**Fitzroy Hotel,
41 Fitzroy Street, Camden.
London. W1T 6DZ**

Design and Access Statement,

**Application for removal of modern
partitions, internal re-arrangement.
Repair and restoration of windows
and front door. Re-instatement of
historical features. Retain existing
hotel use.**

8.0 Response to –application- 2022/2705/PRE: 41 Fitzroy Street

Basement floor

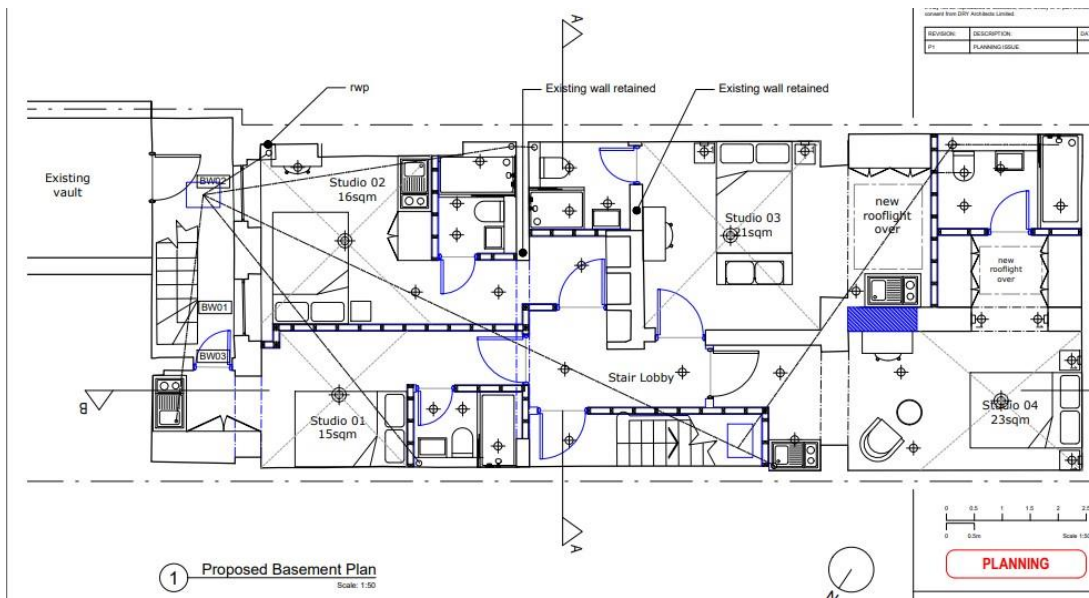
Basement The basement level is proposed to be more comprehensively re-planned. It is accepted that this is a space which has suffered extensive loss of historic features. The proposals at this level are likely to be broadly acceptable, apart from the loss of what appear to be historic wine bins within an original storage area, which is one of the few remaining historic features at this level. If a window is to be proposed under the area steps it will need to read as a traditional timber door with some (limited) glazing.

Ground floor

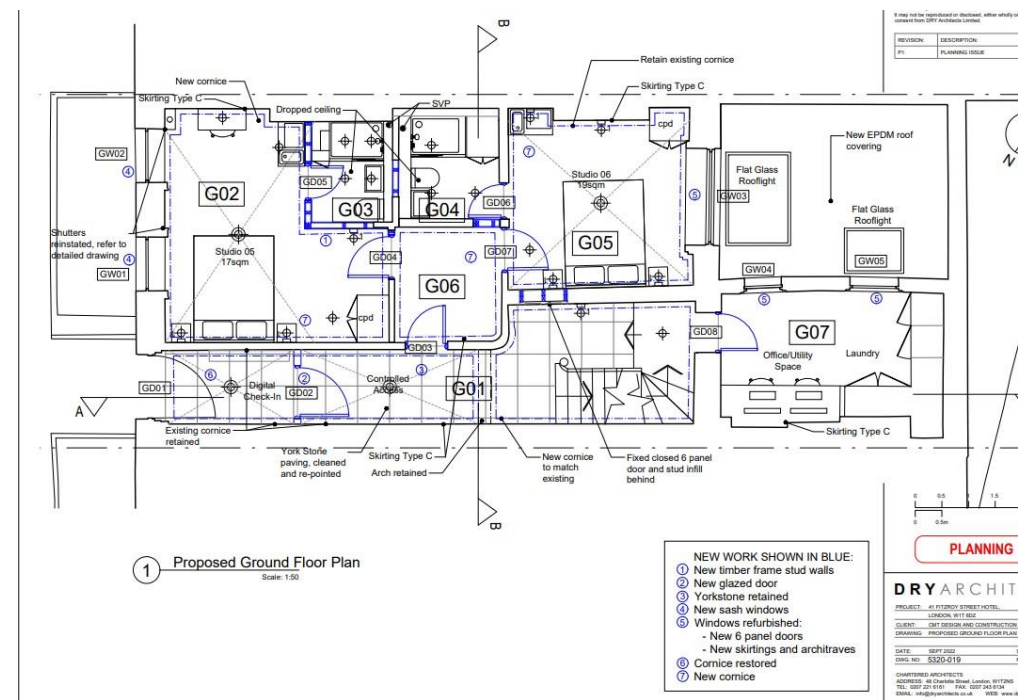
Alterations by floor Ground floor At ground floor, the existing plan form will be retained, maintaining the historic arrangement of a principal room to the front with secondary room to the rear, with the addition of an en-suite within the front room. Ordinarily this would not be acceptable, but it is accepted that the front room has already been altered and that the original chimneypiece has been removed. The existing ensuite has already compromised the legibility of the chimneybreast. The existing en-suite will be retained and re-used to serve the studio located in the rear room, and the proposed lobby arrangement is largely what exists at present. It is not usually acceptable to consolidate harm in a front room, but it is accepted that the net result would not realistically obscure the historic planform any more than the existing arrangement, although it would not necessarily better reveal or enhance significance either. There are works of restoration proposed to the front room, including the reinstatement of shutters. The entrance hall will be restored with the existing cornice and York stone floor retained and repaired. It is accepted that the entrance hall is one of the more significant spaces within the building, having undergone the least alteration. The proposal to remove the doorway from the hall to the rear room would not be supported, but an appropriately detailed door (6 panel) which was fixed shut would be acceptable.

The door way between the hall and the rear room has already historically been blocked up. It is not proposed to block up any original openings.

First floor

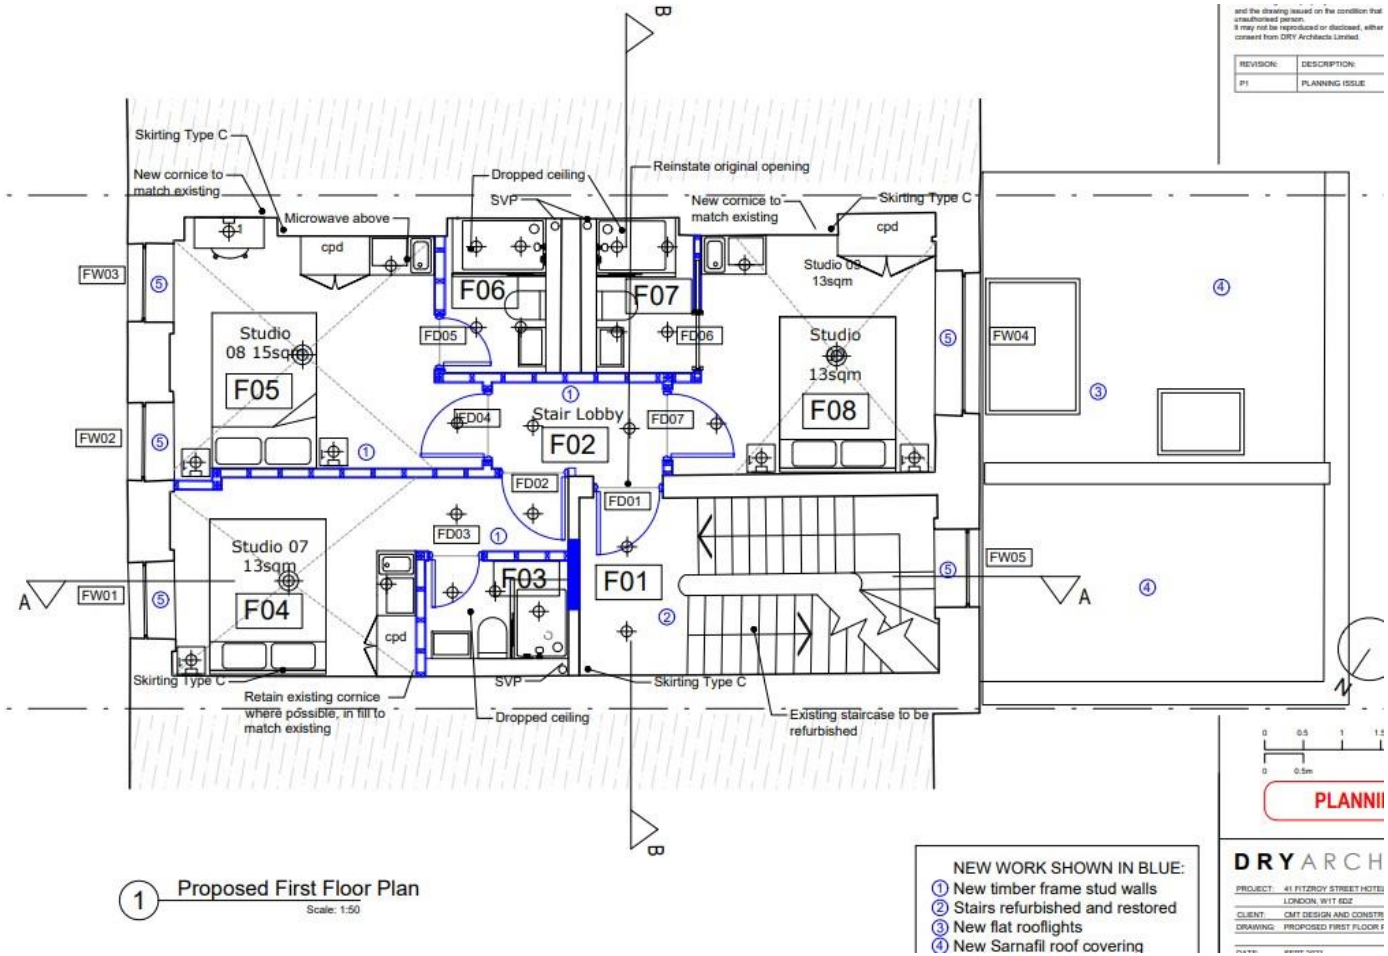
The blocked doorway will be opened giving access from the stair and the existing doorway will be blocked up. The front room will be retained as two rooms as per the existing arrangement, but with a slightly different configuration. This will not entail the loss of historic fabric save for a modest section of wall to create the stair lobby. A downstand will be retained at ceiling level to enable the retention of the cornice which will be retained and repaired. Where sections of cornice are missing, these will be pieced in like for like. The proportions of the spaces at this floor level have already been compromised through the insertion of the corridor and ensuites such that it is considered less sensitive to further change. Internal shutters will be reinstated to the sashes on the front elevation, which is supported as reinstating some significance.

A drawing noting the cornices has been attached with the application

A drawing of the internal shutters to be reinstated has been included with this application

Second floor

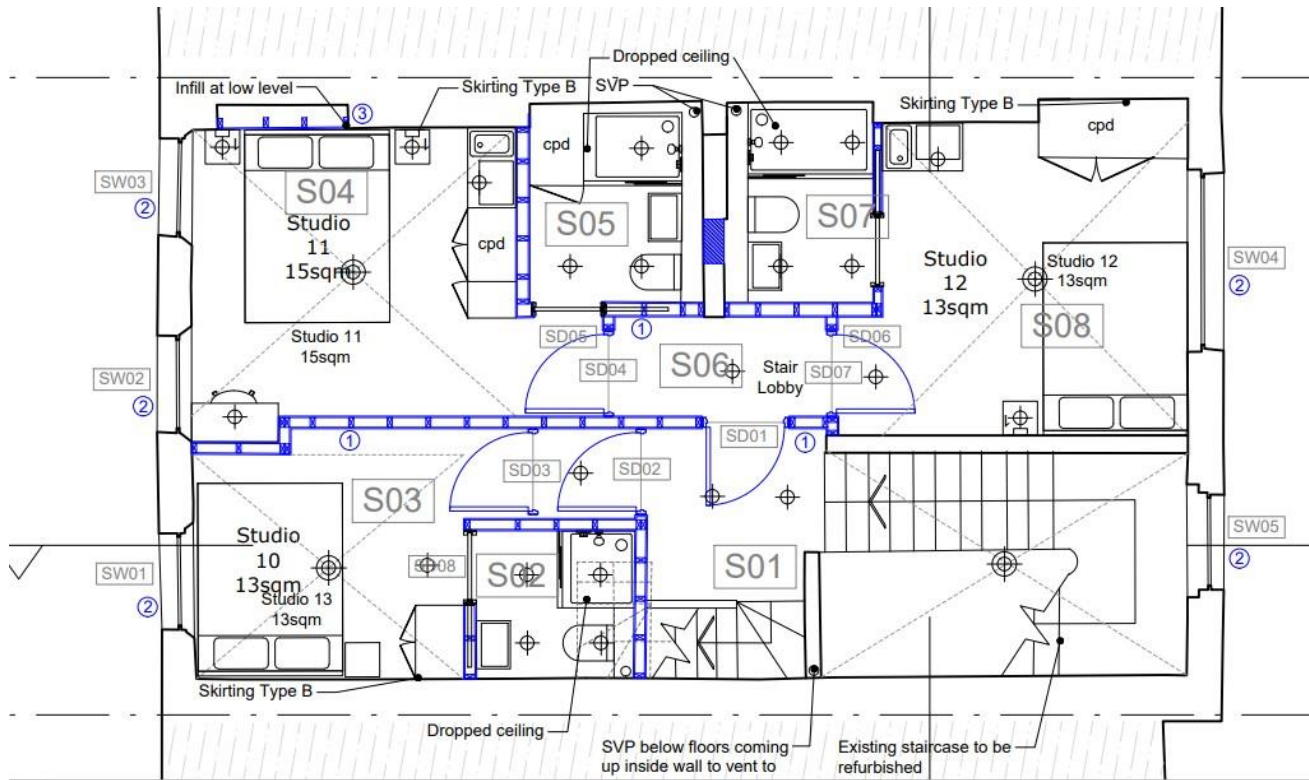
Second floor Like the first floor, the second floor has already been comprehensively reconfigured to create the current arrangement of three rooms, two with en-suite bathrooms and corridor. The scheme maintains the sections of historic partitions that do survive, with a slight reconfiguration of the modern partitions to create three en-suite bedrooms with stair lobby. No historic partitions will be removed.

Third floor

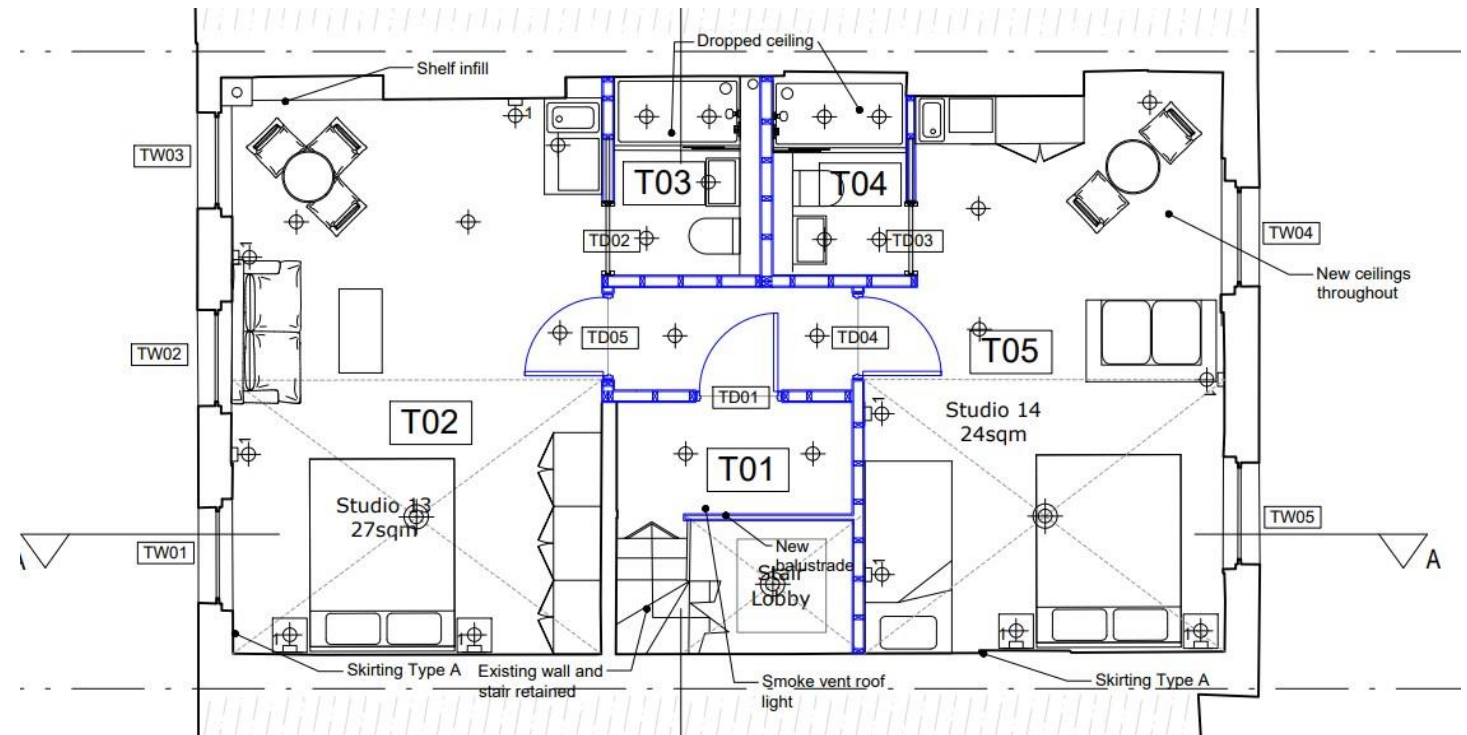
Third floor The third floor is in very poor condition with no surviving historic partitions and areas of ceiling having been lost. The floor will be re-planned to create two larger studios to the front and rear respectively with ensuite bathrooms. Given the extent of loss of historic fabric and plan form, the proposals are not considered to result in any further loss of significance.

Roof plan

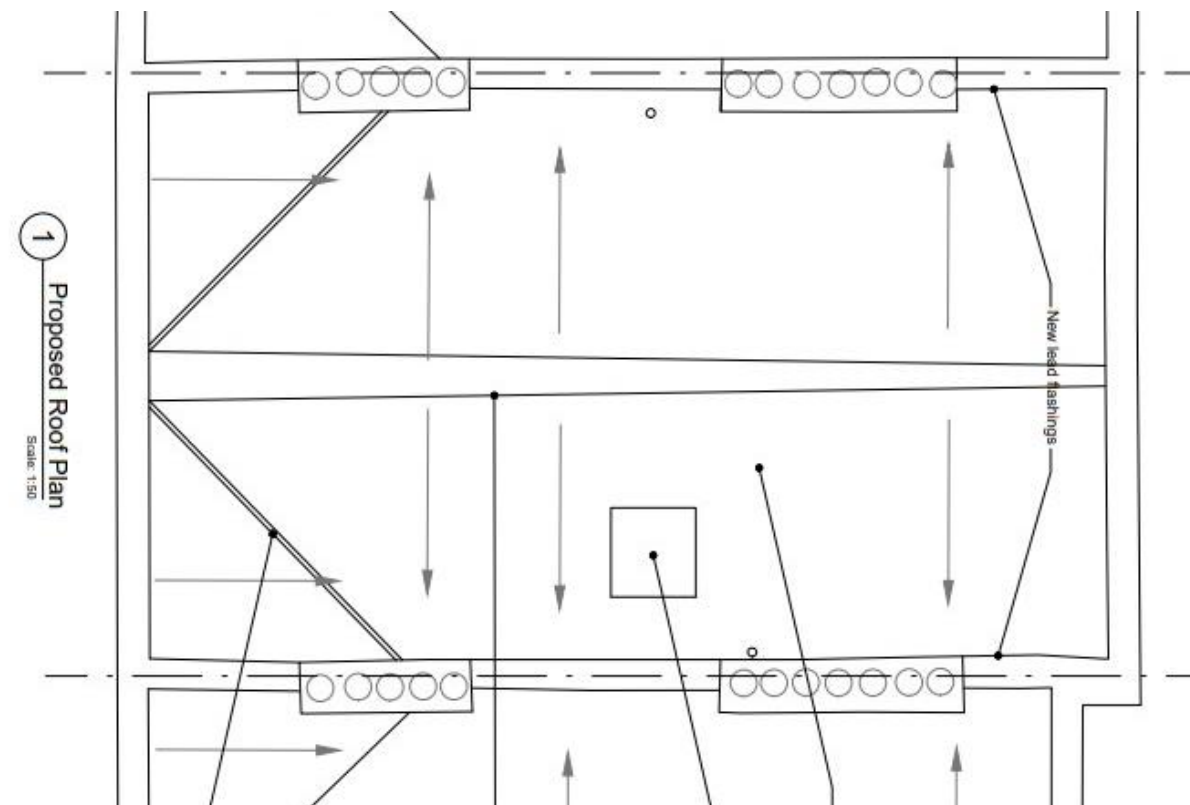
The roof is in a derelict state and will be repaired with replacement timbers and natural slates. This is supported, and encouraged as a matter of urgency.

A full structural survey of the roof has been undertaken by a structural engineer (report attached). The main beam that supports the butterfly roof will be retained and the remaining charred and damage roof structure will be re-built, like for like.
